7.1.3 TPA/54825 - 1799 DANDENONG ROAD, OAKLEIGH EAST - CONSTRUCTION OF A THREE (3) STOREY APARTMENT BUILDING AND ALTERATION OF ACCESS TO A TRANSPORT ZONE

Planning Application TPA/54825 sought approval for the construction of a 3 storey apartment building at 1799 Dandenong Road, Oakleigh East. A refusal was issued on 26 September 2023 and an appeal has been lodged with Victorian Civil and Administrative Tribunal (VCAT) against Council’s Notice of Refusal to issue a Planning Permit.

As part of the VCAT appeal process Council Officer’s attended two compulsory conferences. Following the second compulsory conference, amended plans have been formally lodged with VCAT which seek to address the concerns raised within Council’s grounds of refusal, primarily with regards to neighbourhood character and presentation to the streetscape, landscaping, internal amenity, and impact on adjoining properties.

Image above – refused ground floor layout – split driveway circled in red

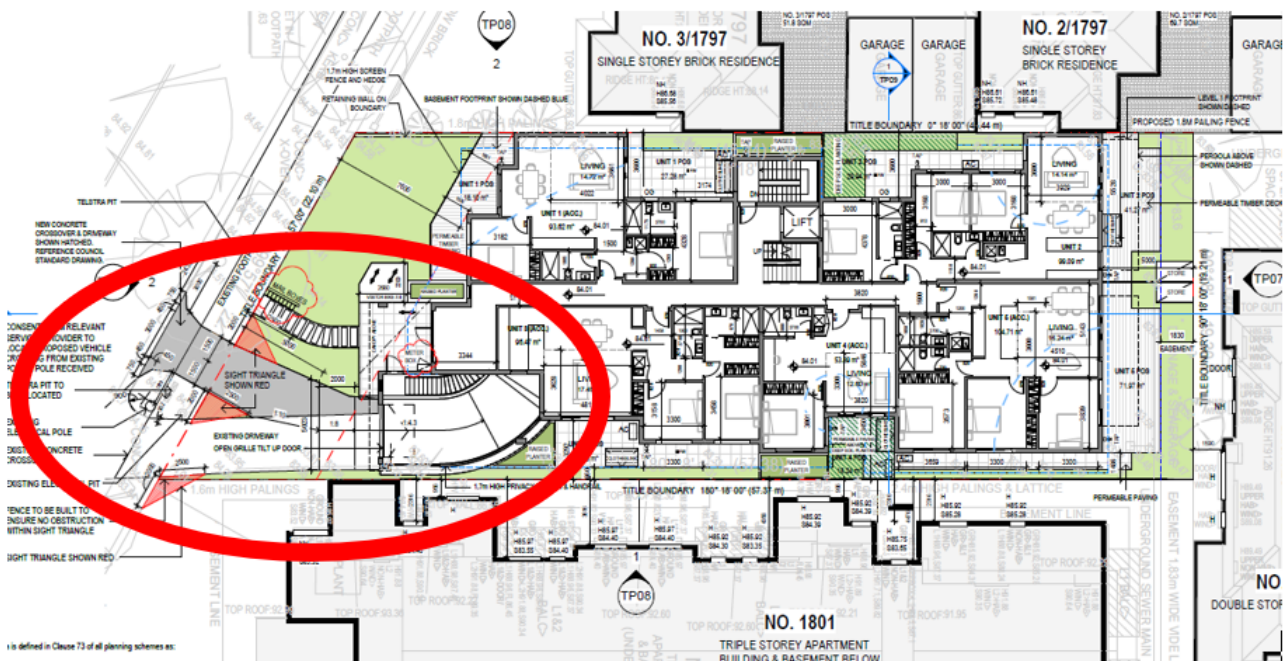
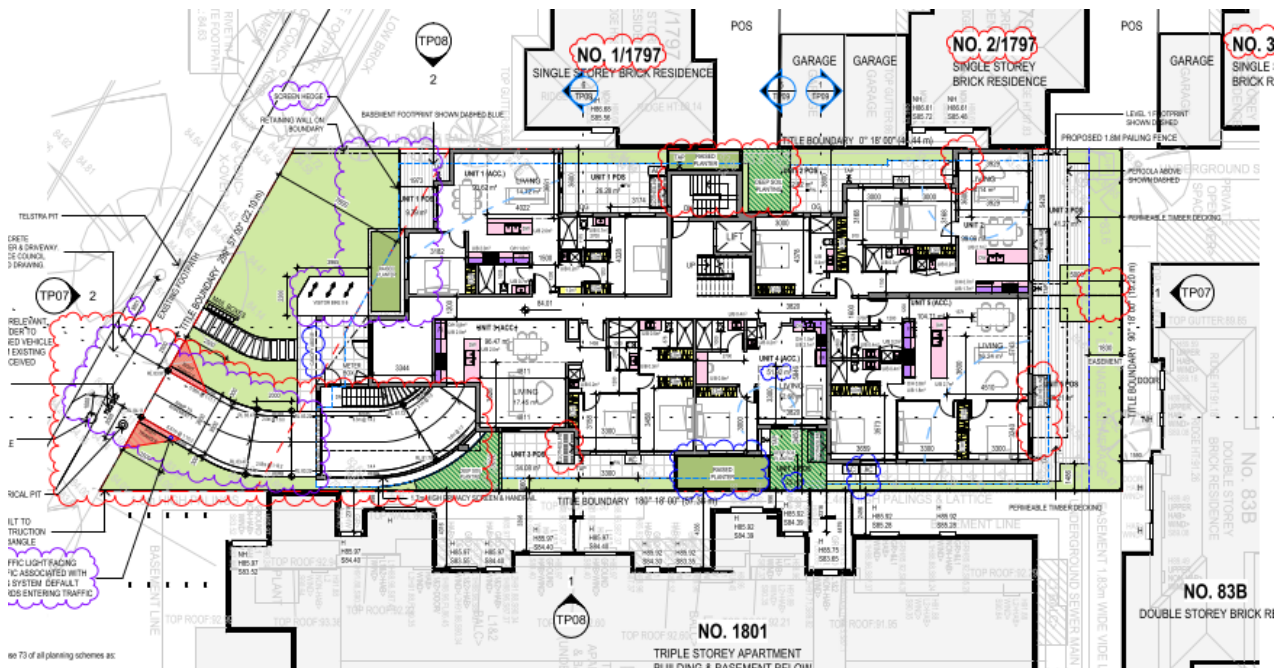
- Modification of the vehicle access to delete the dual driveway and replace with a single vehicle crossover and driveway.
- Removal of an existing second vehicle crossing at the western end of the frontage.
- The revised layout which improves the proposed landscaping opportunities and presentation of the development to the street.
- The revisions to setbacks and apartment layouts address noncompliance with Rescode and to minimise impacts to adjoining properties and increase amenity for future occupants.

The presentation of the development has improved with the deletion of the proposed second driveway and removal of associated hard standing areas. An existing second vehicle crossing at the western end of the frontage is also to be removed and the footpath and nature strip to be reinstated. Additional landscaping is provided in the frontage by removal of excessive decking and the 1.7m high screen fence to provide privacy to SPOS of Unit 1 is to be replaced by hedge planting and planter boxes. The redesign of the driveway has been provided with clearance from a substantial street tree which has a high contribution amenity to the streetscape. The previous design would have had a negative impact on the street tree. This will allow the for the building to reflect the rhythm of built form within the streetscape of a single vehicle crossing and driveway to a single allotment with a landscaped frontage.

Image above – proposed ground floor layout.

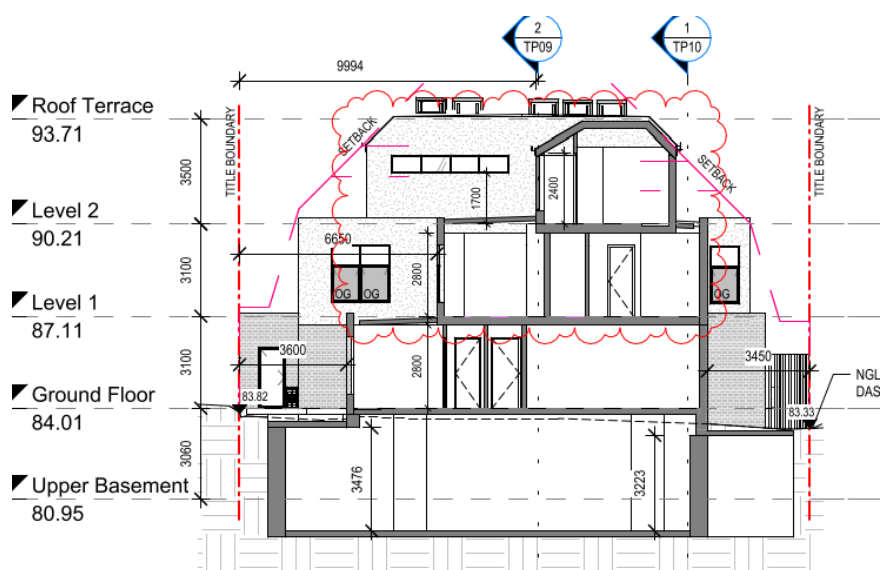
The amended plans have increased side setbacks to address concerns with non compliances with the recommended setbacks in Standard B17 *Side and rear setbacks* and B19 *Daylight to existing windows objective facing windows objective* of Clause 55.04-1 and 55.04-4. These standards are now met as a result of the following changes:

- Replacement of first floor parapet to the flat roof with mansard roof to increase setback from both side boundaries.
- Lowering of the roof to Apartment 11 at second floor.

- Increase in setbacks along the western boundary as follows:
 - Reconfiguration of first floor Apartments 7 & 9 with Apartment 7 reduced from 3 bedrooms to two bedrooms and increase sections of the western setback of Apartment 7 to 1797 Dandenong Road from 3.6m to 4.99m in one section and opposite the corridor the setback has increased from 3.6m to 6.65m.

Image above – original landscape plan

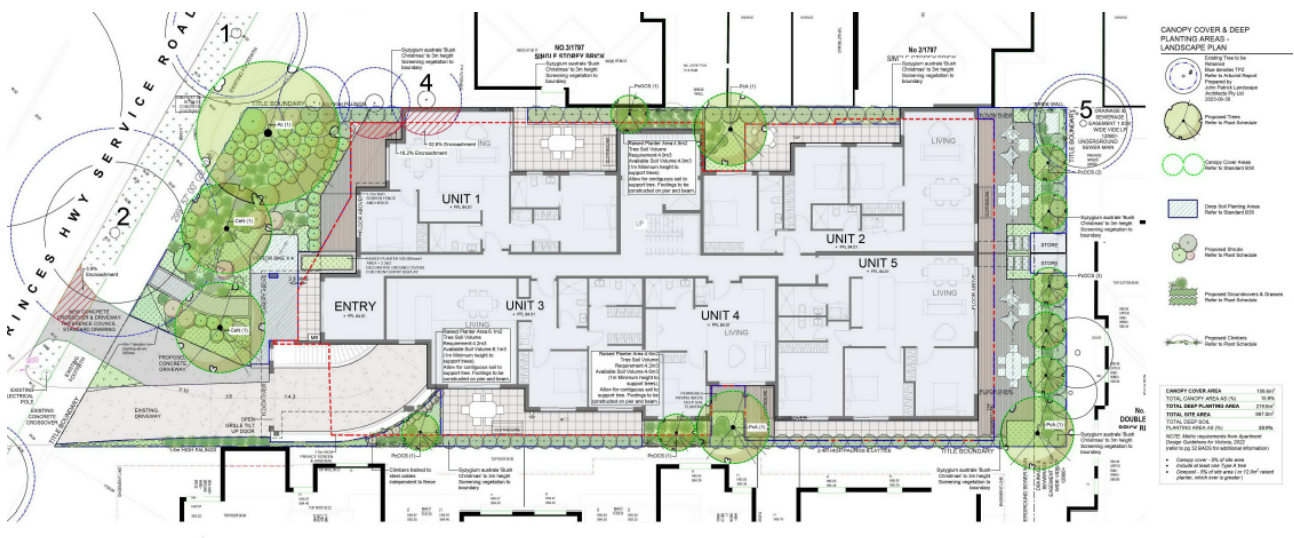
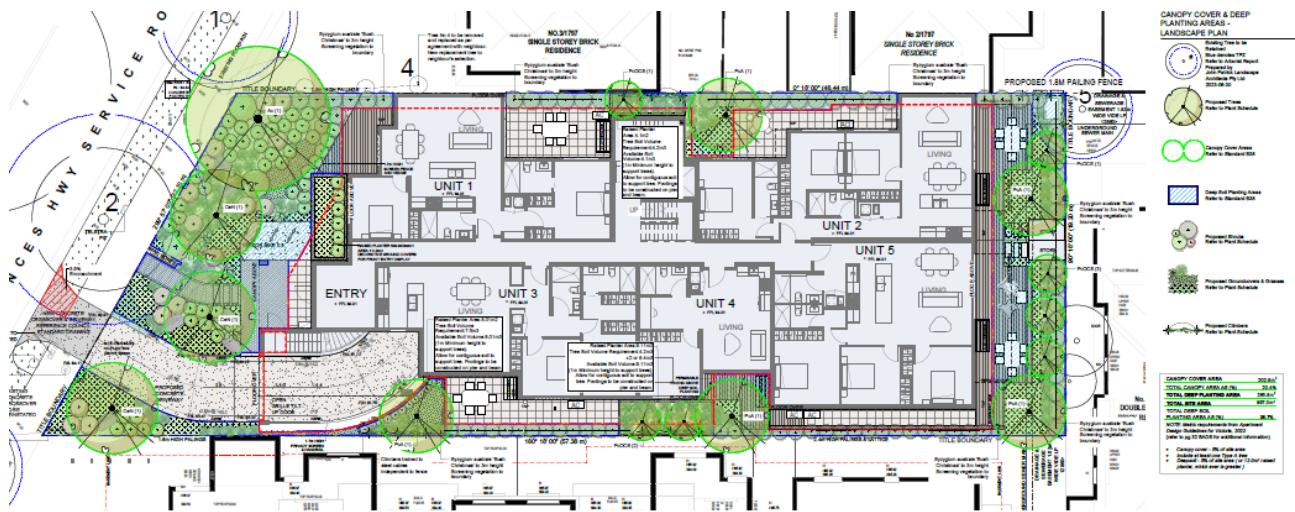
The revised landscaping plans have made substantial changes to the original plans with additional opportunities provided in the front setback by the redesign to delete the second driveway and vehicle crossing. This reduces excess hard standing area in the frontage and addressed one of the major concerns with the proposed development as shown in the below images:

Image above – amended landscape plan
